LA QUINTA INN ADDITION SITE PLAN

Project: La Quinta Inn Addition
City of Grove City Application #201409020046

In response to your letter dated September 12, 2014 we off the following responses:

Staff has reviewed your development plan application for the La Quinta Inn Addition located at 3962 Jackpot Road. The control number for this application is #201409020046 and should be referenced on any future correspondence concerning this matter.

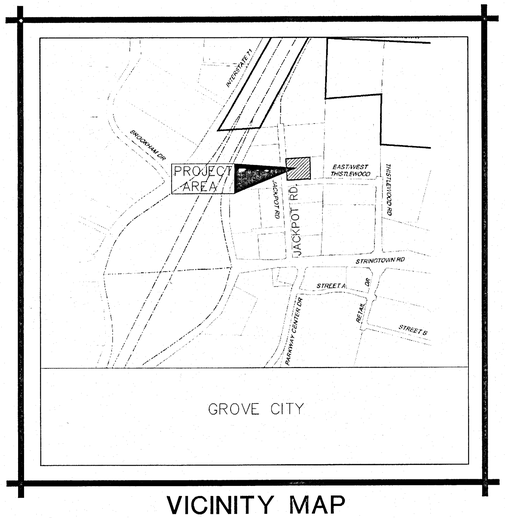
19. Note should be placed on plans stating that "The premises covered by the plans has been survey and the plans are correct" based on Development Plan Application Checklist Item 30.

THIS PROJECT CONSISTS OF THE SITE DEVELOPMENT FOR AN ADDITION TO THE LA QUINTA INN WITHIN THE CITY OF GROVE CITY. THE PREMISES COVERED BY THE PLANS HAS BEEN SURVEYED AND THE PLANS ARE CORRECT.

17. The striping has been modified to show the 8' van accessible aisle.
18. The existing water service has been added to drawings 3, 4, and 5 of 5.
19. The requested note has been added to Drawing 1 of 5.

LA QUINTA INN SITE PLAN
GROVE CITY, OHIO
DEMOLITION PLAN

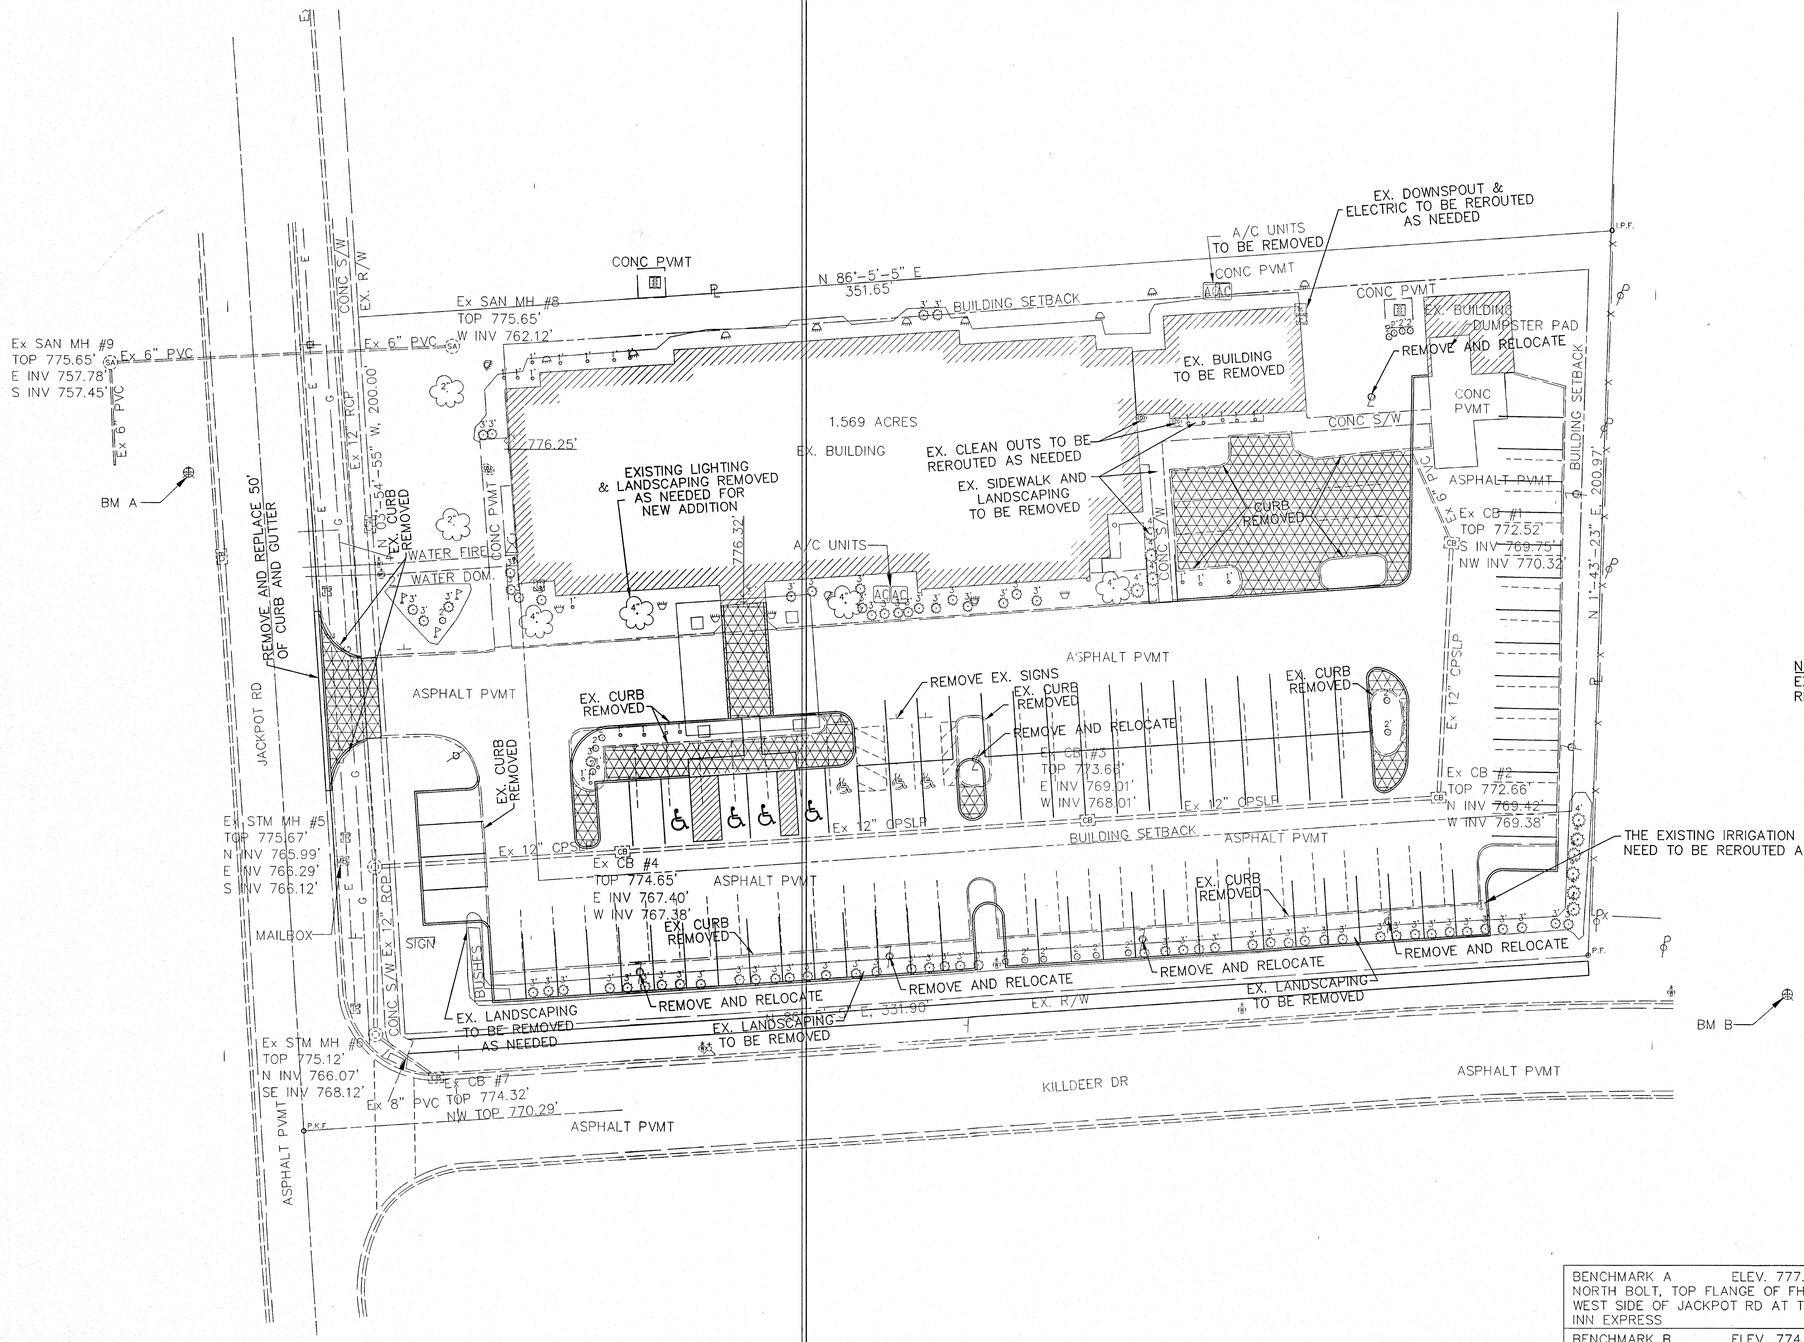
15. Development Plan Application Checklist Item 4 requires property dimensions and site acreage. Property line dimensions and site acreage should be labeled on the plan.

18. Existing water service/main/main size and location information should be labeled on the Site Plan as required by Development Plan Application Checklist Items 16 and 18.

14. The protection fence is noted on Drawing L1.0.
15. The property dimensions and site acreage has been added to Drawings 3, 4 and 5 of 5.
16. See item #5 above.

LA QUINTA INN SITE PLAN
GROVE CITY, OHIO
DIMENSION PLAN

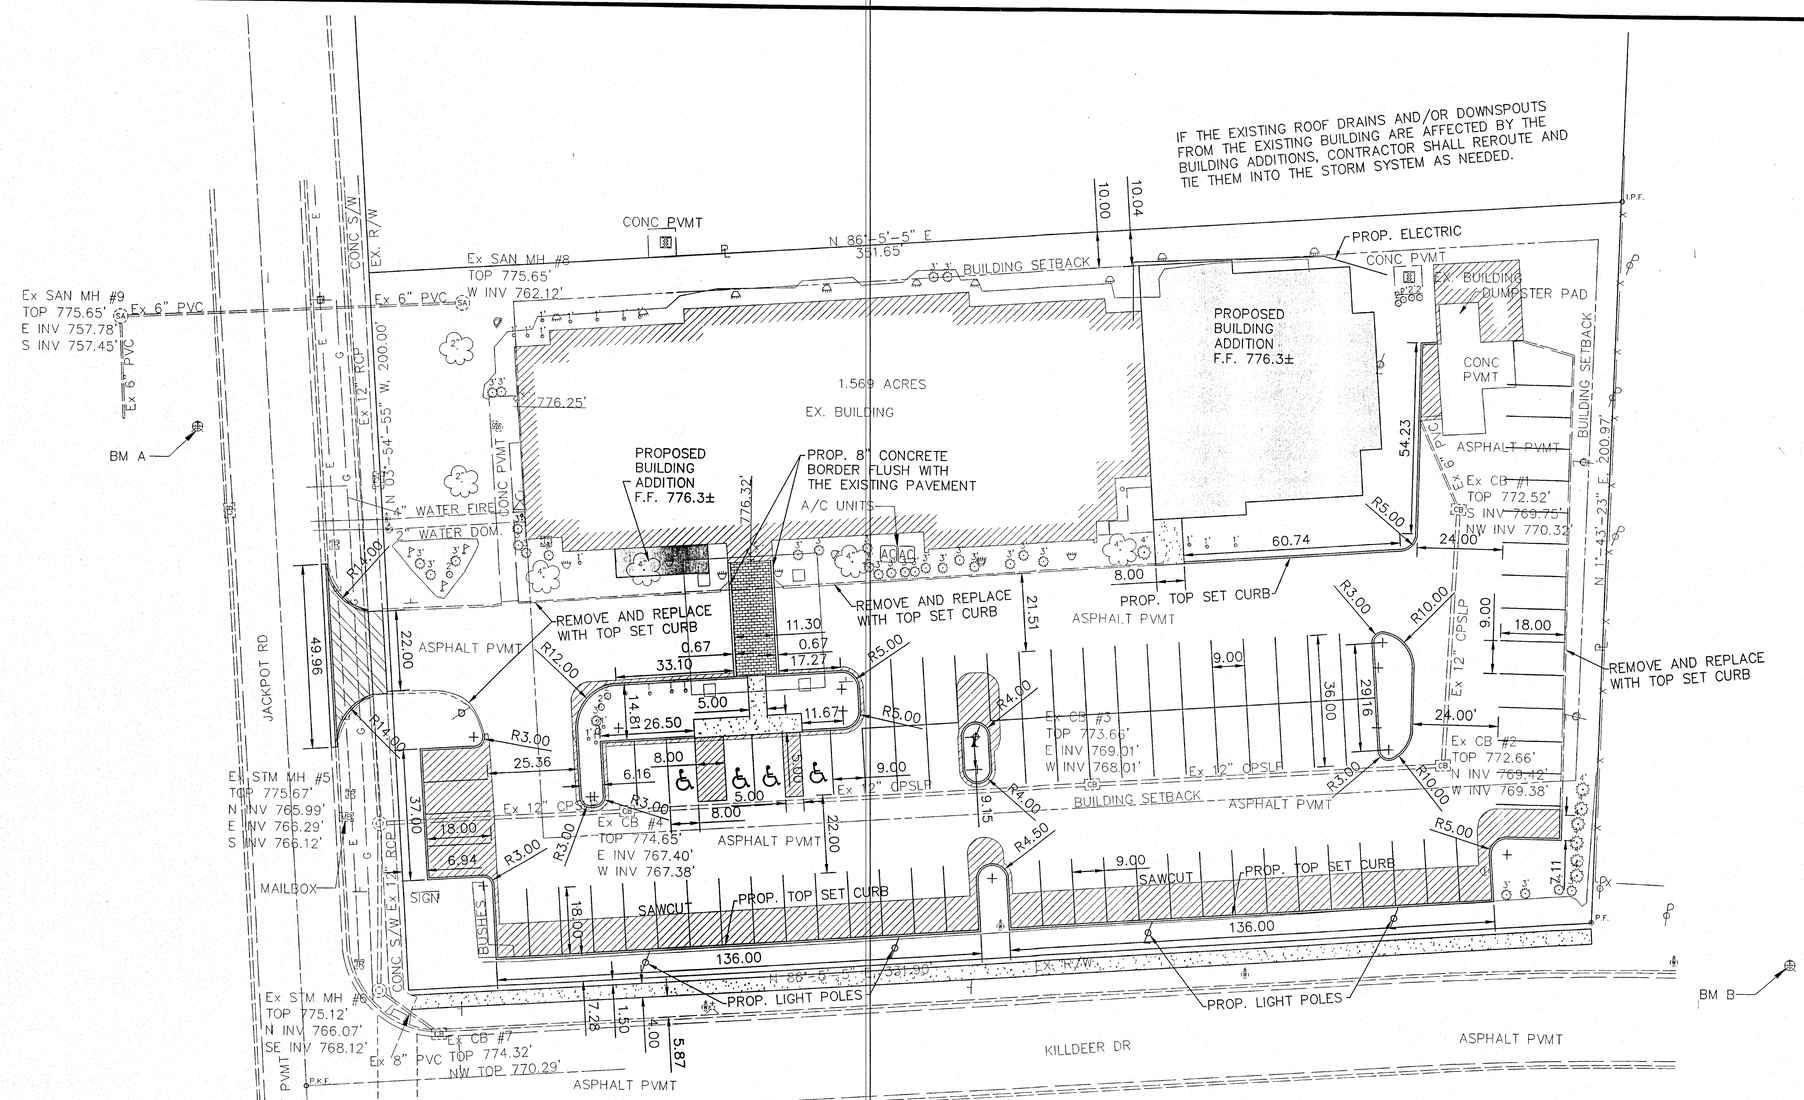
1. A site plan of the proposed improvements should be submitted which does not show existing conditions.
2. The total number of hotel rooms after the expansion should be noted on plans in order to determine parking requirements. Code requires one parking space per room/suite.

1. The site plan has been revised to not show the existing conditions.
2. The total number of hotel rooms has been added to Drawing 4 of 5 under the Notes section.

PLANTING PLAN

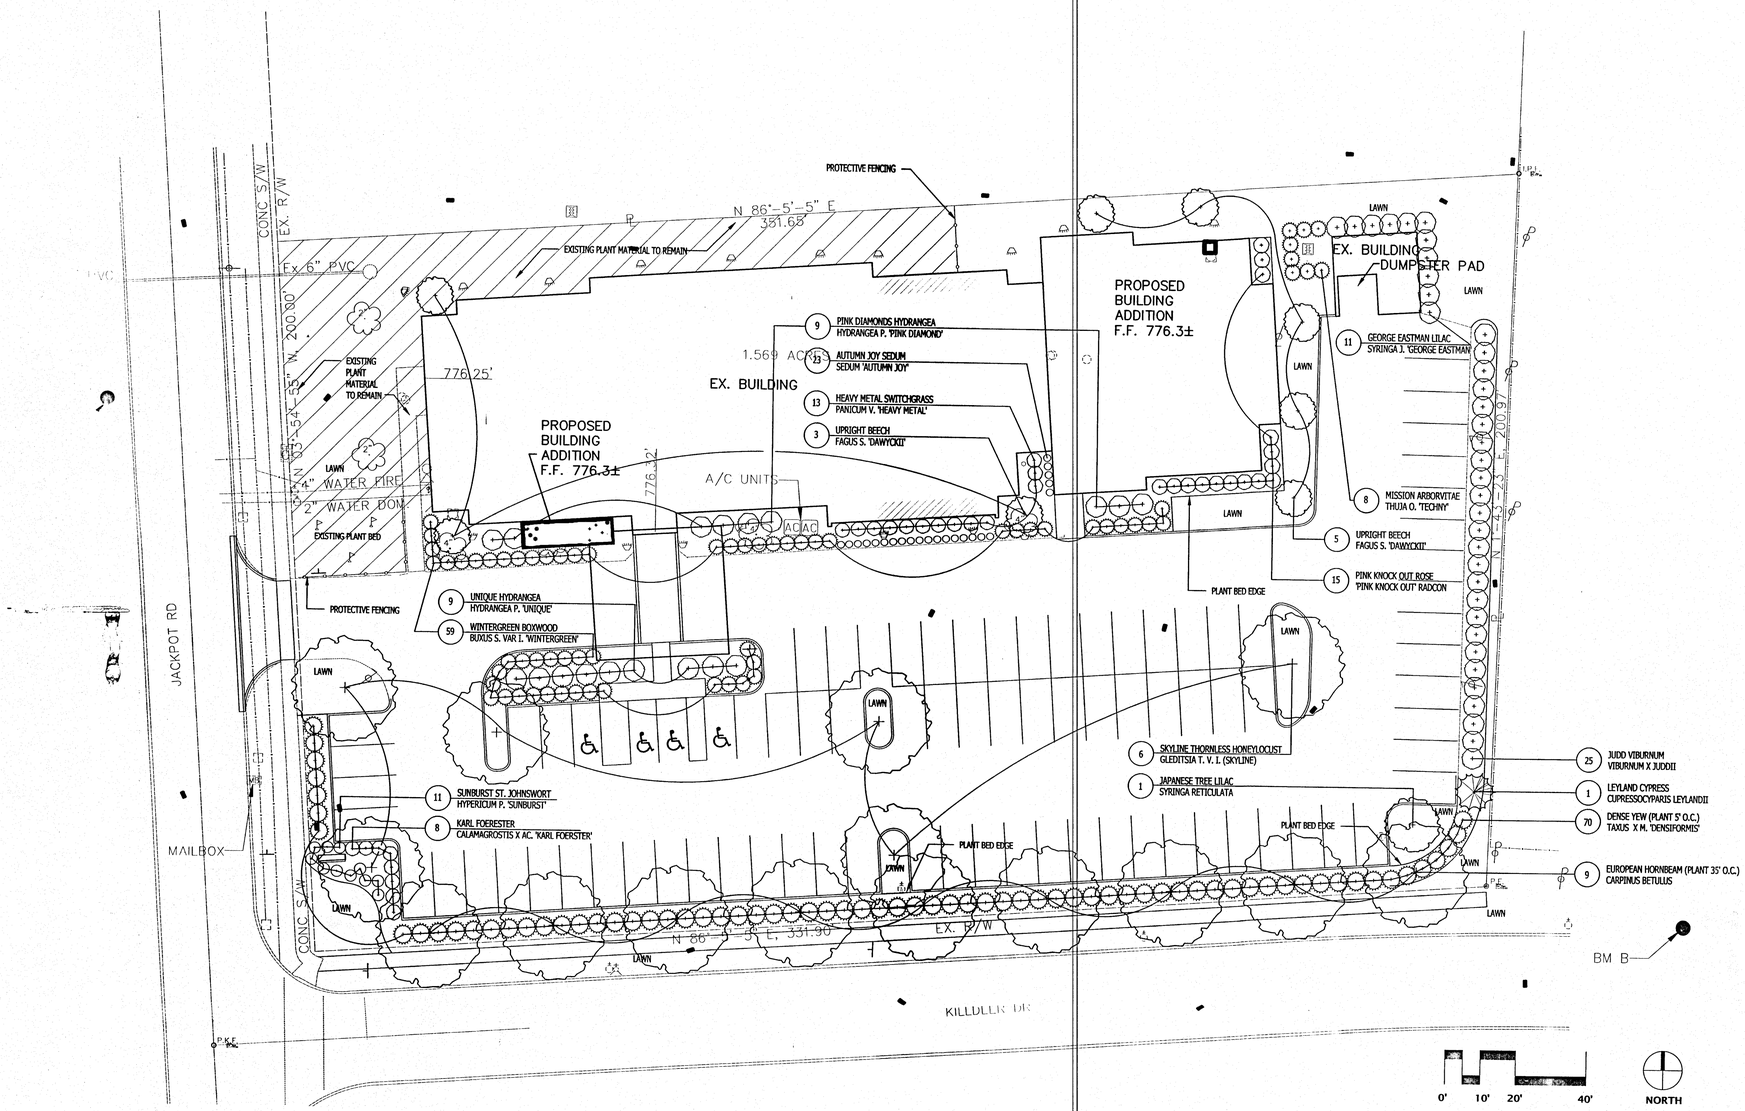
3. The proposed parking lot does not meet the 15' south or west setbacks. Furthermore, the southern parking lot planting bed edge and trees appear to be proposed within the right-of-way. Staff could support a deviation from the setback requirements if justification for the infringement is given; however staff cannot support improvements installed within the right-of-way. All improvements should be on the La Quinta property.

13. 1136.08- Screening of Service Structures- Dumpster will need supplemental landscaping- 36" height minimum plantings at 5' maximum spacing around the enclosed portion of the structure

14. 1136.10: Preservation of Trees and Wooded Areas- any landscaping that is to remain during the construction process must be preserved with signage and fencing per this code. Please make a note on the plans that this procedure will be followed if any of the landscaping is to remain.

3. The landscaping has been redesigned so it is on the property.
4. We have kept the top set curb due to the existing is currently top set and will add unnecessary cost to the project.

11. The property owner's signature has been added to the application.
12. A sidewalk has been added along Killdeer.
13. Screening of the dumpster building has been added.

SHEET NO.
A2.1
EXTERIOR ELEVATIONS

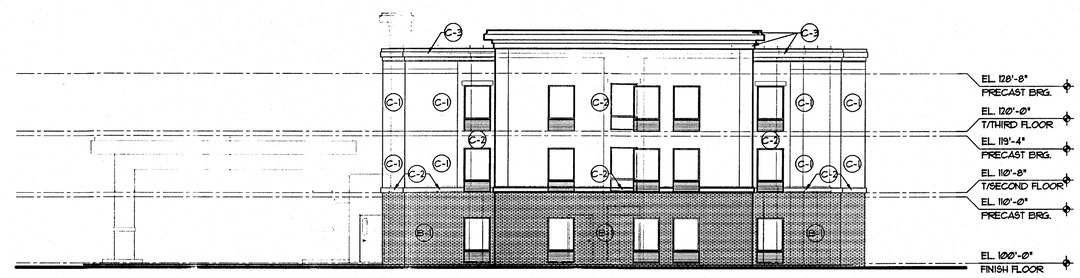
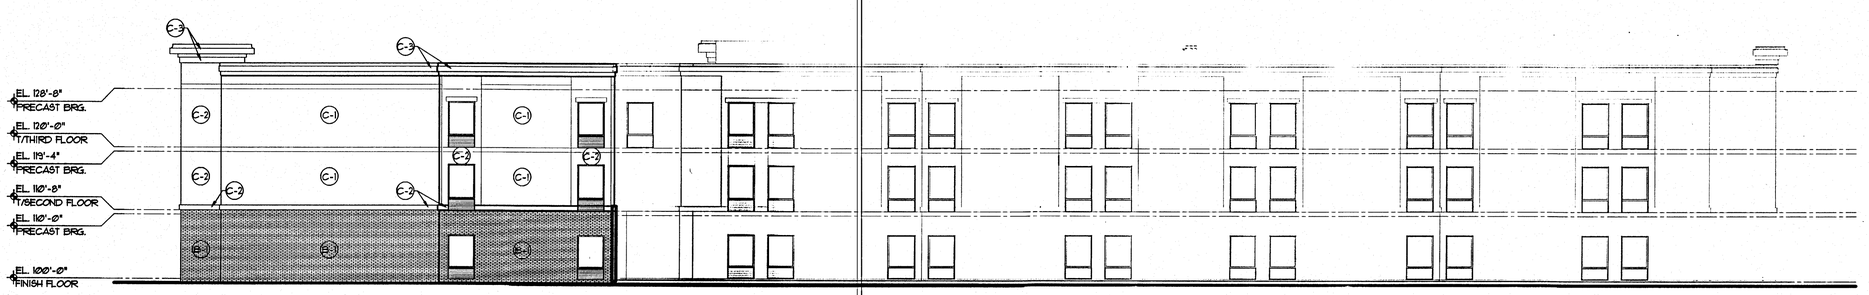
6. A note should appear on plans stating that any rooftop-mounted mechanicals on the building expansion will be screened by the building parapet.
7. A photometric plan should be submitted showing that all pedestrian and vehicular areas meet the 0.5 footcandle minimum.

NOTE: ANY NEW ROOF-TOP MECHANICAL UNITS SHALL BE SCREENED BY THE BUILDING PARAPET.

5. We would like to have the 9'x18' parking spots approved.
6. The note to screen roof top units has been added to Drawing A2.1.
7. The photometric plan is attached in this submittal.
